Motel Parking Needs Contradictions and Confusions

POINTS TO CONSIDER

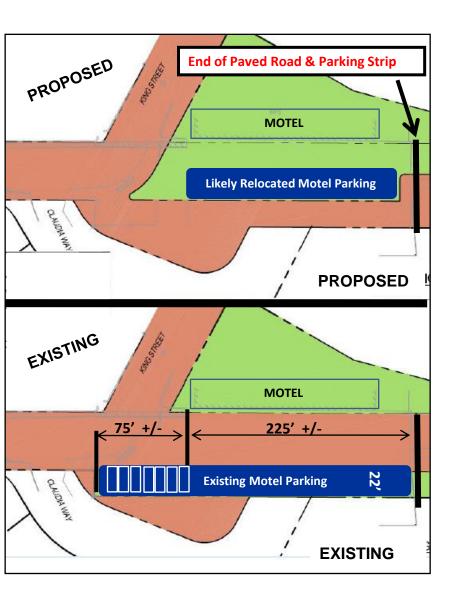
- 1. The proposed plan <u>eliminates</u> several parking spaces <u>for the motel</u> toward Claudia Way (see white hash marks in blue rectangle below).

- 2. Why is the motel voluntarily giving up 75 feet +/- of valuable parking spaces? They should reveal their future plans for redevelopment of the building given the loss of parking.

- 3. The proposed configuration likely places a row of cars on existing Depot Street. Cars will have to maneuver on paved surface so potential green space frontage for the motel is obviously not possible.

- 4. This plan would result in cars making <u>multiple maneuvers</u> in front of the motel unit entrances.
- 5. The proposed plan <u>reduces the maneuvering width</u> from **72 feet** (parking strip + Depot St.) to only **50** feet.

- 6. Residents have proposed a hammerhead or two near the end of Depot Street for many years to facilitate a public drop-off and handicap parking. The Town Engineer stated the 50 foot road is not wide enough for a hammerhead. This plan contradicts that.

- Since the motel owners have agreed to reduce their parking and abandon potential green space frontage, then parking could simply be moved across the street in front of units leaving 50 feet of public road for safer maneuvering.

- 8. For a fair EVEN swap, an increase of six feet in width (from 22' to 28') would make up for the spaces lost AND give the motel a safety and aesthetic buffer of green space frontage. Depot Street would be reduced from 50 to 44 feet which, when combined with the Town's parcel at Claudia Way would provide many design opportunities for a turnaround, emergency beach access, and development of the Ocean Gateway Park concept. Leaving only 22 feet for the Town does not.
